# Access Compliance Report

## Public Rights-of-Way

### (Curb Ramps)

Intersection ID: 11993	Main Street: MEREDITH_AV	Cross Street: PRUITT_ST	Location: NE
ADA ID: 1EADF8098999	Ramp Type: Perp	Initial Pass/Fail: Fail	Overall Compliance: No
			Severity Score: 33.75

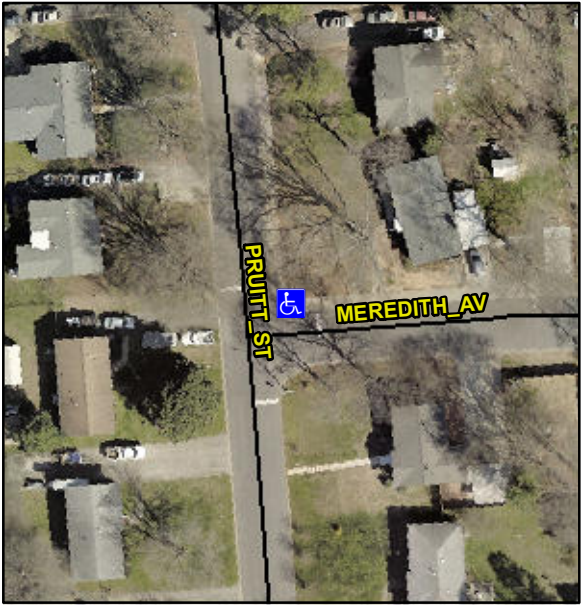
Codes/Mitigation Info/Possible Solution			Field Measurements/Component Compliance		
	Possible Solutions:		<b>Compliance</b>	<b>Description</b>	<b>Data</b>
	<b>Remove &amp; Replace Entire Ramp.</b>		<b>N/A</b>	Ramp Length (in)	<b>76.0</b>
			<b>No</b>	Ramp Width (in)	<b>47.5</b>
			<b>N/A</b>	Flare Type LT	<b>N/A</b>
			<b>N/A</b>	Flare Slope LT (%)	<b>N/A</b>
			<b>N/A</b>	Flare Traversable LT?	<b>N/A</b>
			<b>N/A</b>	Landing Length (in)	<b>N/A</b>
			<b>N/A</b>	Landing Width (in)	<b>N/A</b>
			<b>N/A</b>	Landing Slope (%)	<b>N/A</b>
			<b>N/A</b>	Landing X Slope (%)	<b>N/A</b>
<p>Surveyor Notes:</p> <p><b>N/A</b></p> <p>PROW/ADA:</p> <p><b>Not Found, R304.5.1, R304.5.3</b></p>			<b>N/A</b>	Flare Type RT	<b>N/A</b>
			<b>N/A</b>	Flare Slope RT (%)	<b>N/A</b>
			<b>N/A</b>	Flare Traversable RT?	<b>N/A</b>
			<b>N/A</b>	DWS Provided?	<b>N/A</b>
			<b>N/A</b>	DWS Contrast?	<b>N/A</b>
			<b>N/A</b>	DWS Length (in)	<b>N/A</b>

<b>N/A</b>	DWS Full Width?	<b>N/A</b>
			<b>N/A</b>	DWS Offset (in)	<b>N/A</b>
			<b>N/A</b>	Shared Landing?	<b>N/A</b>
			<b>N/A</b>	Gutter Ponding?	<b>N/A</b>
			<b>N/A</b>	Gutter Lip Ht (in)	<b>N/A</b>
			<b>N/A</b>	Painted X Walk1?	<b>No</b>
				X Walk 1 Direction	<b>To S</b>
			<b>N/A</b>	X Walk 1 Width (in)	<b>N/A</b>
				X Walk 1 Slope (%)	<b>0.3</b>
				X Walk 1 X Slope (%)	<b>6.6</b>
			<b>N/A</b>	Ramp inside XWalk1?	<b>N/A</b>
				Road Slope (%)	<b>6.6</b>
				Road X Slope (%)	<b>0.3</b>
			<b>N/A</b>	Any Obstructions?	<b>N/A</b>
Total Cost:		<b>\$ 1850.00</b>		Obstruction Type	
			<b>N/A</b>		<b>N/A</b>
			<b>Yes</b>	Surface Condition? (G/P)	<b>Good</b>
